January 16, 2023

Re: Failed Inspection at 2035 SW Hook Farm Drive (Carter Plan)

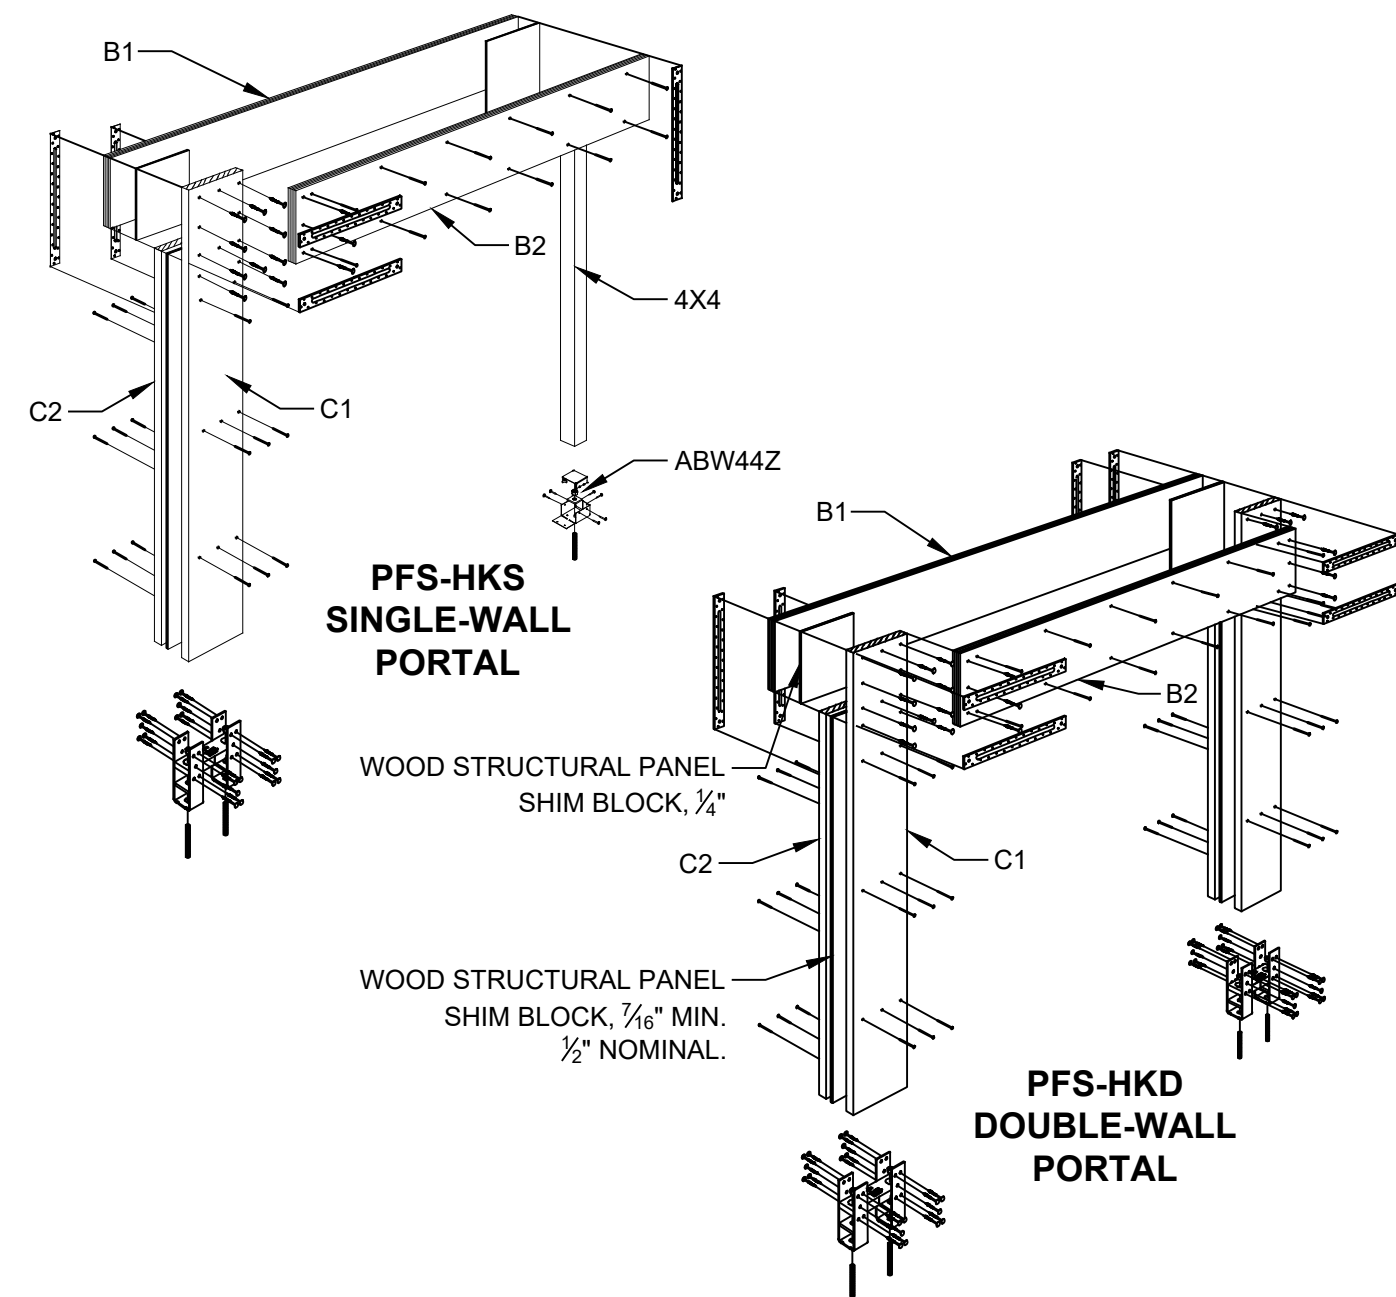
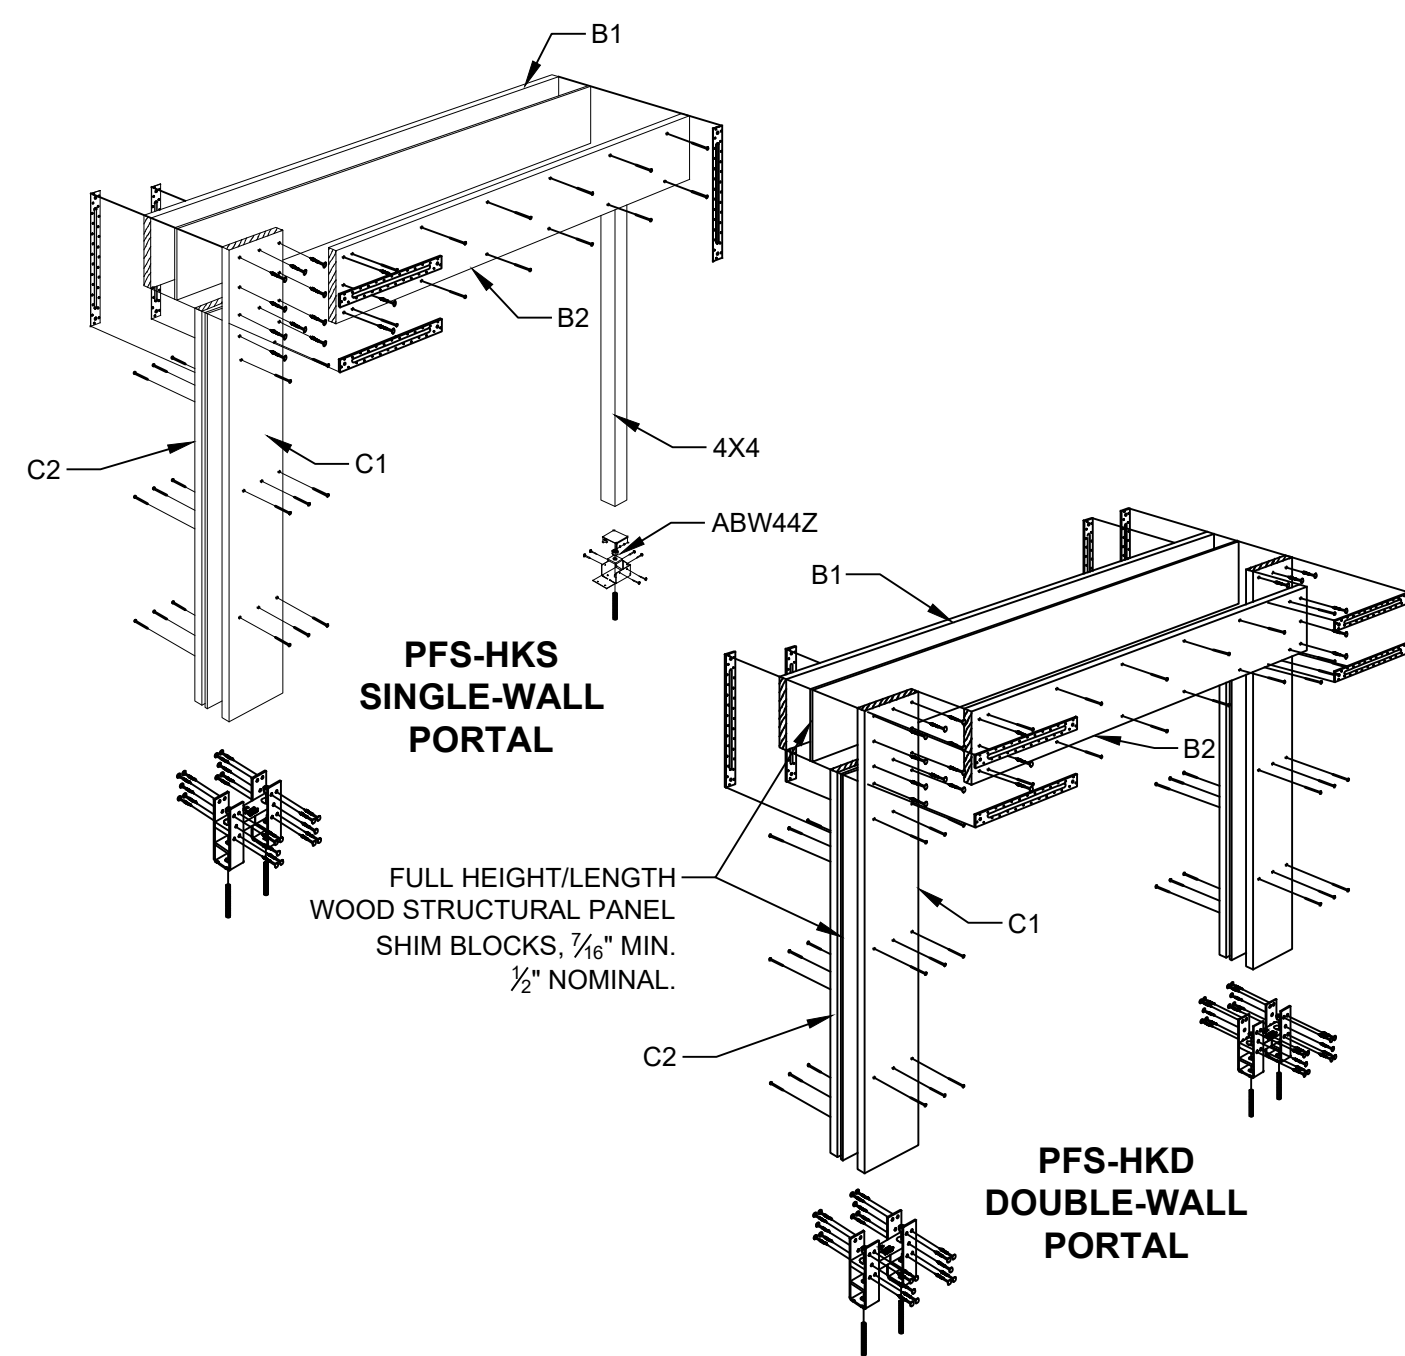
I have reviewed the framing inspection report for the subject address which notes that the wall bracing at the rear dining room window which is specified as CS-PF is not adequate to meet the code requirements. In my initial review and approval of these plans I failed to recognize that the adjacent wall panel width (approximately 12") does not meet the minimum requirement specified by IRC Table R602.10.5 of 18" for a CS-PF portal brace. It is unclear why the continuous wall sheathing was not applied to the exterior surface of this wall at the time of construction. The photographs you have provided me indicate that the wood structural panel sheathing has been applied to the interior surface and nailed to meet the CS-PF nailing requirements. The absence of any wall panel or framing anchors tying this sheathing to the rim joist below along with the inadequate panel width contribute to the failure to meet code requirements. I propose the following procedure to provide what I feel will be sufficient lateral capacity at this wall to meet the intent of the code even though it admittedly does not meet the letter of the code:

- 1) Attached is a PDF of Simpson Strong-Tie drawing of their portal frame system which would have been in retrospect the proper application for this issue using the PFS kit. We will try to replicate system #5 in the drawing titled "Double Wall Portal Installation" using the existing interior sheathing and some additional Simpson strap ties.

- 2) The four lateral strap ties shall be Simpson MSTC 28 strap ties fully nailed to the header and the framing members on the sides.
- 3) The four vertical straps shall be Simpson SSP stud plate ties nailed into the end studs and king studs on each end of the window. Blocking needs to be placed below the plywood in the floor to attach the outstanding leg of these ties with Simpson SD wafer head screws.

- 4) I propose that the combination of the shear strength provided by the interior sheathing enhanced by the strapping modifications above, along with the strength provided by the exterior LP panel siding and the interior gypsum drywall will be adequate for the bracing of this relatively short section of braced wall.
